Roche Site

May 2009
HTA Architects for
George Wimpey

Design & Access Statement

George Wimpey | DPP | HTA | DTA | Environmental Design Partnership

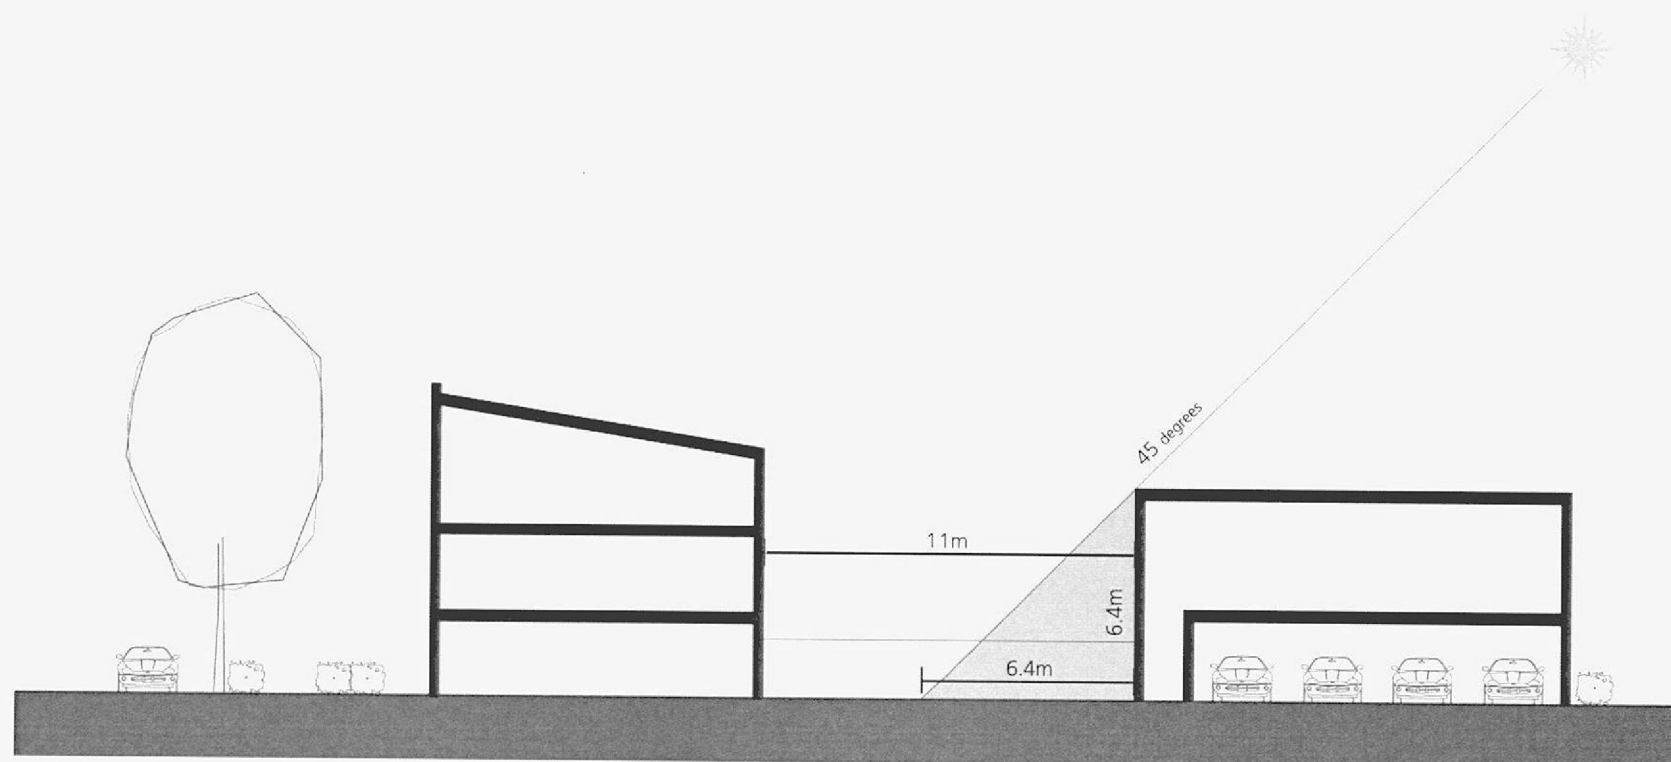
Whilst block 1 is promoting a total number of units similar to that envisaged in the masterplan there are concerns that the layout could be improved upon. The use of FOGs dominates and overshadows the rear gardens of the units in front.

As illustrated adjacent, there is just a small portion of the private gardens that is overshadowed by the FOGs. Please note that all back gardens of Block 1 properties are facing south and that the FOGs are 11m from the rear of the house, therefore the partial overshadowing will provide some relief from the direct sun.

Block 1

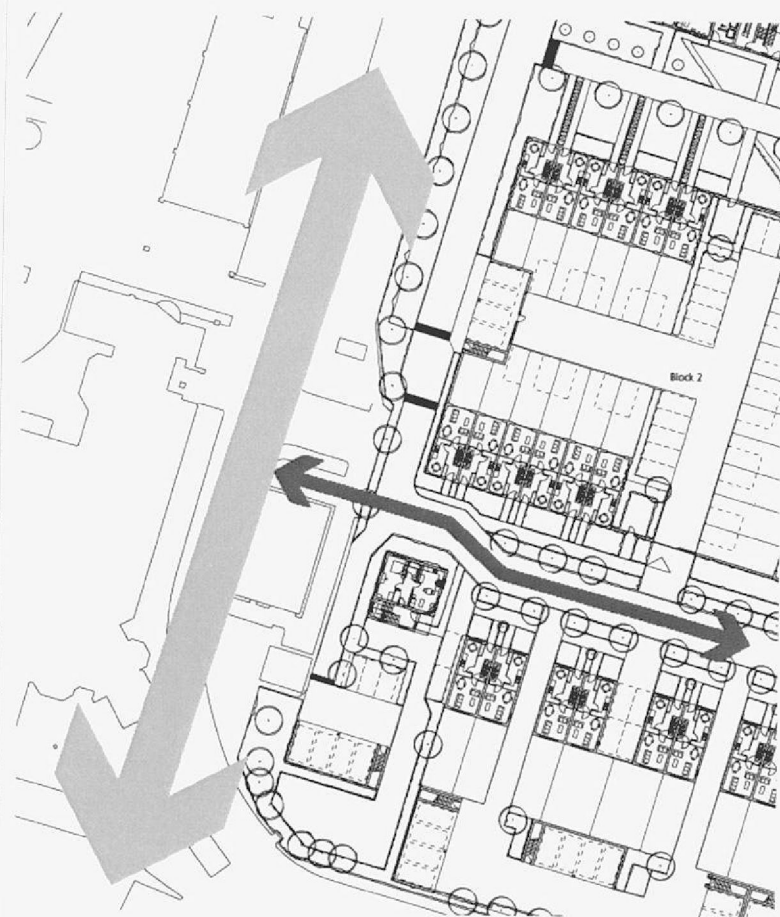
The individual block of flats seems to float within its site, not properly terminating the vista and resulting in a large area of underused land. The question must be asked as to whether this is really the innovative approach to design that the SPD is requiring.

This block has been carefully positioned in order to terminate the vista of the southern footpath (as illustrated adjacent) and signify a change in road treatment from a standard solution to a shared surface along the western edge. The reduction of the route at this point will slow traffic down and promote pedestrian movement.

Section through a block 4 courtyard

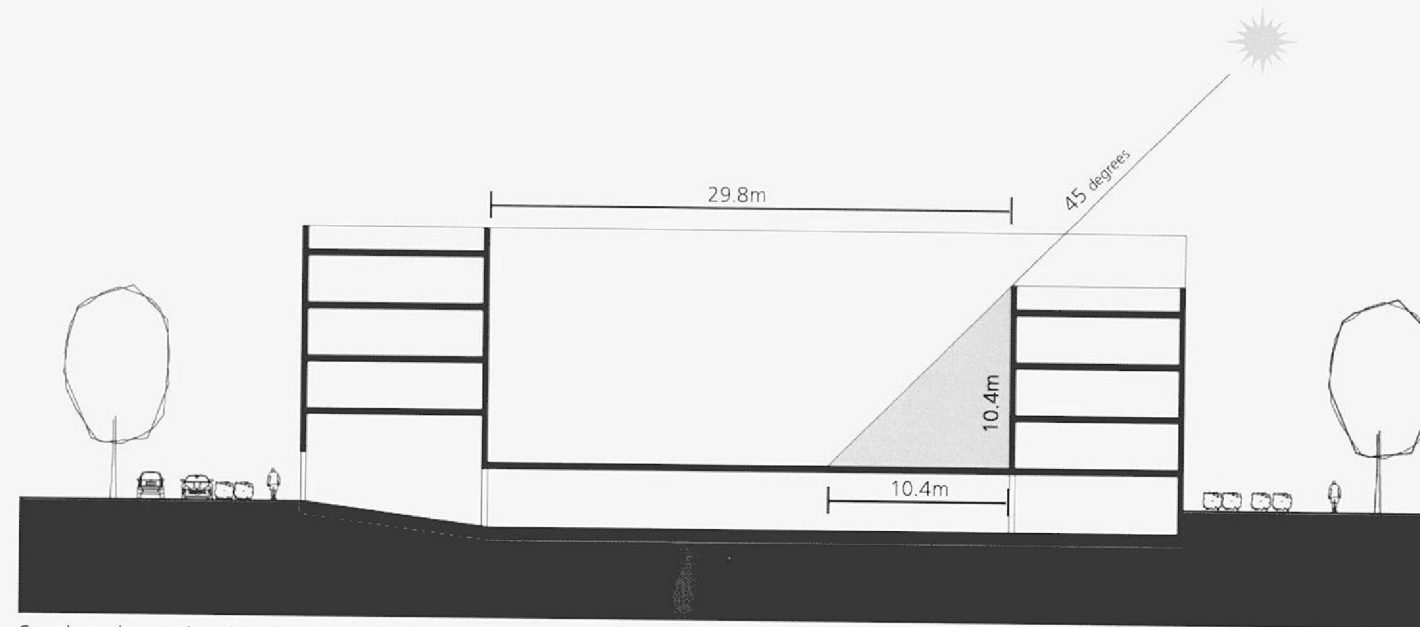
The SPD advises that all residential units should have access to individual or communal private outdoor space which should be attractive, functional and appropriate in size to the estimated number of inhabitants it will serve. In comparison to the SPD there is a significant increase in the numbers of units promoted by these two blocks and there are concerns that the internal courtyards will feel dominated as a result.

Block 4 - Previous scheme above; new scheme below

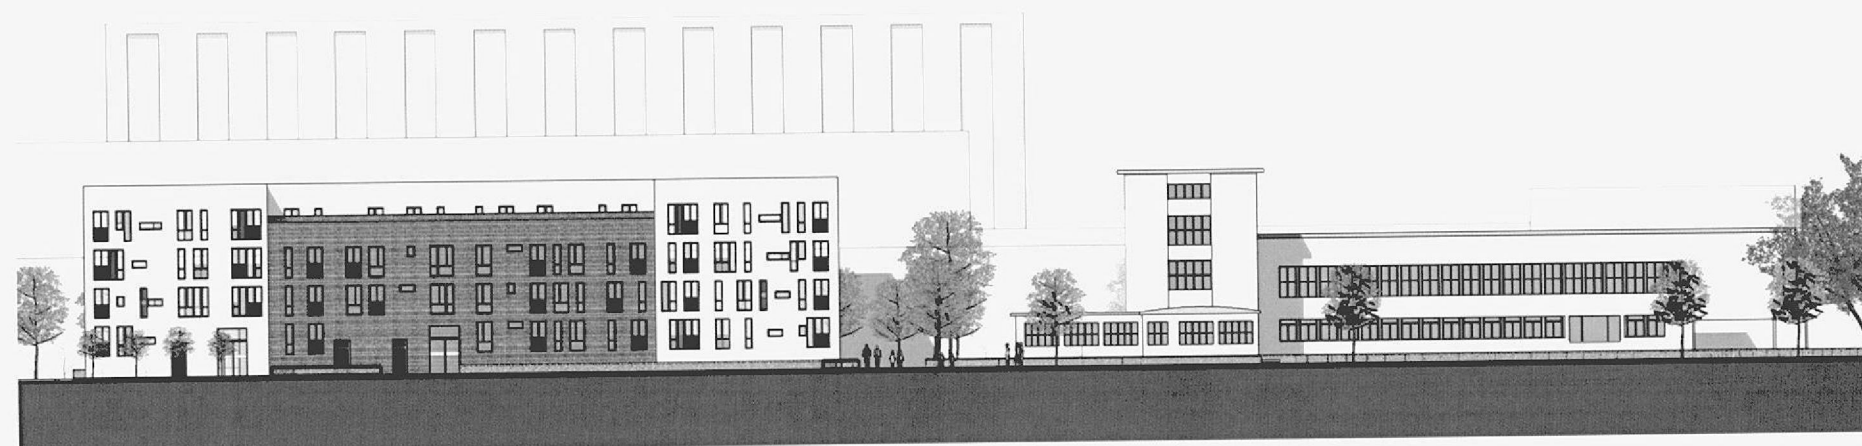
With regard to Block 4 there has not been the opportunity to discuss this building height (which is greater than that envisaged by the SPD) in relation to the impact on the listed building with the Council's listed buildings advisor. There is also a concern that this height is on the northern elevation of the block which could have an impact on the amenity of blocks to come forward on later phases (outside Taylor Wimpey's ownership). Given the Council's concerns on a number of issues relating to the perimeter blocks promoted it is questionable as to whether this block does have a strong design focus. There are concerns that it would result in a large number of residents living within a small perimeter block without there being the compensation of strong architectural or sustainability credentials to consider. So it is questionable as to whether block 4 would be considered acceptable in terms of the criteria listed above and the more detailed areas of concern.

Block 4 has reduced a storey in height, reflecting the height of the Listed Building, we feel this is an appropriate height as the SPD stipulates the height should increase northwards.
